Access Compliance Report

Public Rights-of-Way

(Curb Ramps)

Intersection ID: 13345	Main Street: COMMONWEALTH_AV	Cross Street: THOMAS_AV	Location: NE
ADA ID: A3FB17DA881C	Ramp Type: Perp	Initial Pass/Fail: Fail	Overall Compliance: No
		Severity Score: 8.75

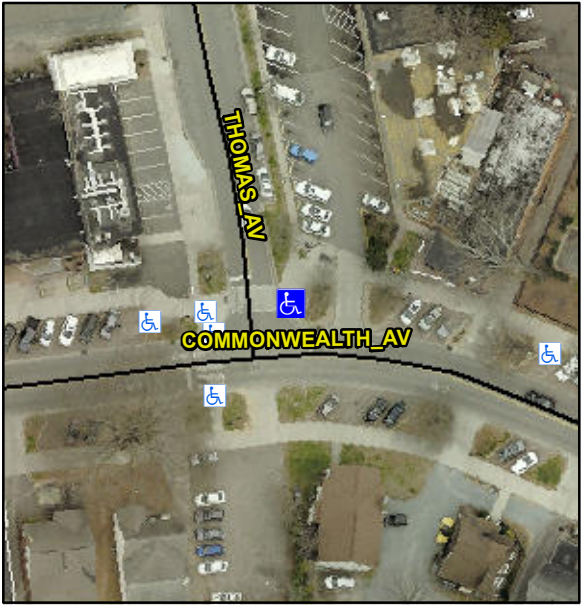
Codes/Mitigation Info/Possible Solution			Field Measurements/Component Compliance		
	Possible Solutions:		Compliance	Description	Data
	Remove & Replace Entire Ramp.		Yes	Ramp Slope (%)	7.6
			No	Ramp Width (in)	1.2
			N/A	Flare Type LT	N/A
			N/A	Flare Slope LT (%)	N/A
			N/A	Flare Traversable LT?	N/A
			N/A	Landing Length (in)	N/A
			N/A	Landing Width (in)	N/A
			N/A	Landing Slope (%)	N/A
			N/A	Landing X Slope (%)	N/A
<p>Surveyor Notes:</p> <p>N/A</p> <p>PROW/ADA:</p> <p>Not Found, R304.5.1</p>			N/A	Flare Type RT	N/A
			N/A	Flare Slope RT (%)	N/A
			N/A	Flare Traversable RT?	N/A
			N/A	DWS Provided?	N/A
			N/A	DWS Contrast?	N/A
			N/A	DWS Length (in)	N/A
			N/A	DWS Full Width?	N/A
			N/A	DWS Offset (in)	N/A
			N/A	Shared Landing?	N/A
			N/A	Gutter Ponding?	N/A
			N/A	Gutter Lip Ht (in)	N/A
			N/A	Painted X Walk1?	N/A
			Yes	Painted X Walk2?	N/A
			To W	X Walk 2 Direction	N/A
			N/A	X Walk 2 Width (in)	N/A

1.8	X Walk 2 Slope (%)	N/A
			1.3	X Walk 2 X Slope (%)	N/A
			N/A	Ramp inside XWalk2?	N/A
			N/A	Clear Space?	N/A
			N/A	Clear Space to XWalk (in)	N/A
			N/A	Any Obstructions?	N/A
			N/A	Obstruction Type	N/A
			N/A	Storm Grate/Utility Hazard?	N/A
			N/A	Storm Grate/Utility Type	N/A
			N/A	Surface Condition? (G/P)	Good
Total Cost:		\$ 1850.00
